RE: Erosion Protection Works at Old Bar
DP524933 – DP1028979 incl Meridian Resort
Your Ref: DOC12/34287

In response to your letters of 7th & 27th August 2012 requesting further information regarding the above application, the specific concerns identified have been addressed below. Also enclosed is a hard copy and electronic copy of the amended drawings [revision A] and consent of owners of 38 & 40 Lewis St. If an amended Statement of Environmental Effects is required, please advise.

Figure 3 – Sketch identifying [in green] owners who are supportive of an extended wall alignment

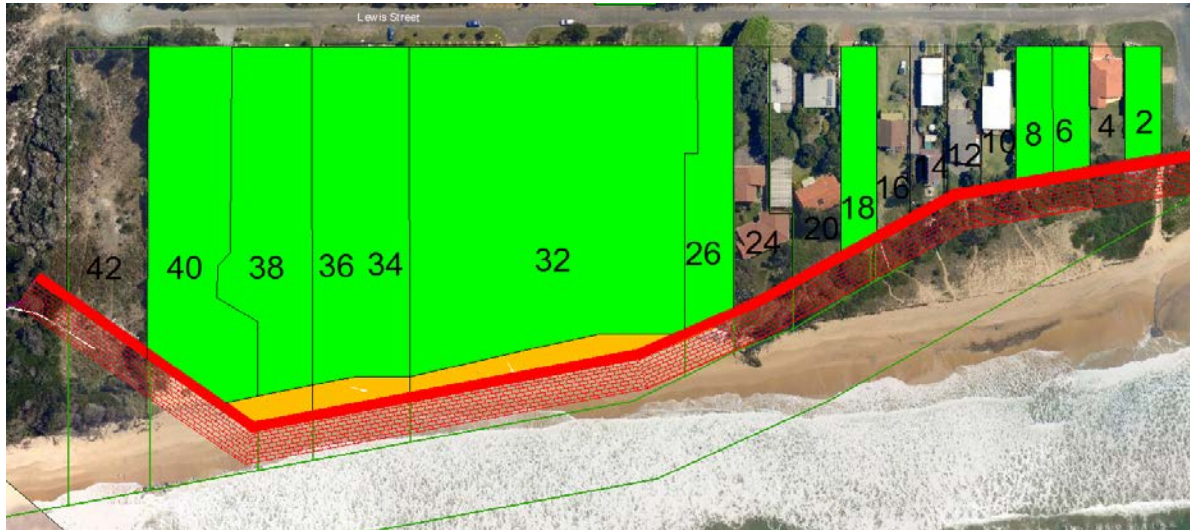
- How 'end effects' are proposed to be addressed and managed by the proponents in the short and long term (i.e. if erosion impacts on adjoining properties are increased);

As part of the submissions to the NSW Coastal Panel in response to this application, a number of owners have indicated that they would be supportive of an extended wall alignment (properties of supportive owners marked in green in Figure 3). The remaining owners did not object to the initial proposal (which included allowance for extension of the walls as required).

Figure 4 – Area of SEPP26 Littoral Rainforest

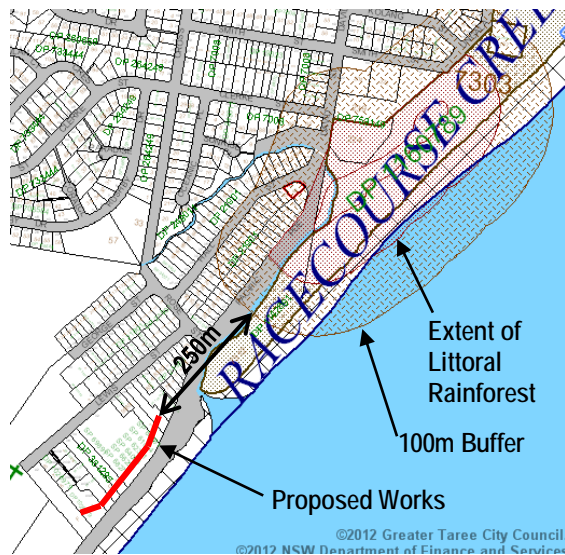
- The potential for impacts on dune vegetation from increased erosion resulting from the seawall and how this is to be managed, especially the *State Environmental Planning Policy No 26 – Littoral Rainforest* area to the north of the site;

The proposed works are located more than 250m south of the 100m buffer zone surrounding the SEPP26 designated littoral rainforest [Figure 4]. As the Worley Parsons [2010] Coastline Management Study indicates a net littoral drift to the south and southerly transport during storm conditions (when the upper beach profile is most likely to be affected), it is expected that the impact of the proposed works would primarily be to the south and the potential for impact on the littoral rainforest some 350m to the north is expected to be fairly limited. It is noted, however, that this area is naturally very vulnerable to erosion and is also affected by the dynamics of Racecourse Creek. This may need to be reassessed in the event of additional erosion making the extension of the wall substantially to the north necessary / desirable.

Figure 5 – Overlay of Pipeline with Proposed Works

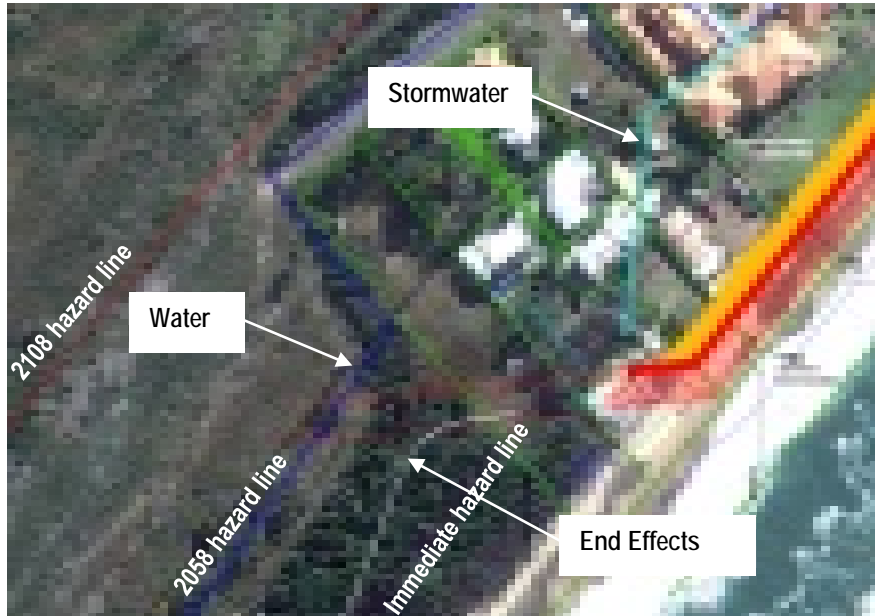
- Any storm water management impacts;

Overlay of these pipeline locations provided by MidCoast Water in their response to the application [Figure 4] indicates that the initial works footprint is clear of existing stormwater, water and sewer pipelines. The worst-case potential for end effects is also initially well clear of the pipelines [Figure 5]. In the medium-term, however, this water pipeline may become affected by erosion which has been exacerbated by the proposed revetment. It is noted, however, that this pipeline is already within the 2058 hazard zone and as such is already vulnerable to erosion. Plans for its eventual protection are unknown, however relocation of this service landward appears to be feasible [Figure 6].
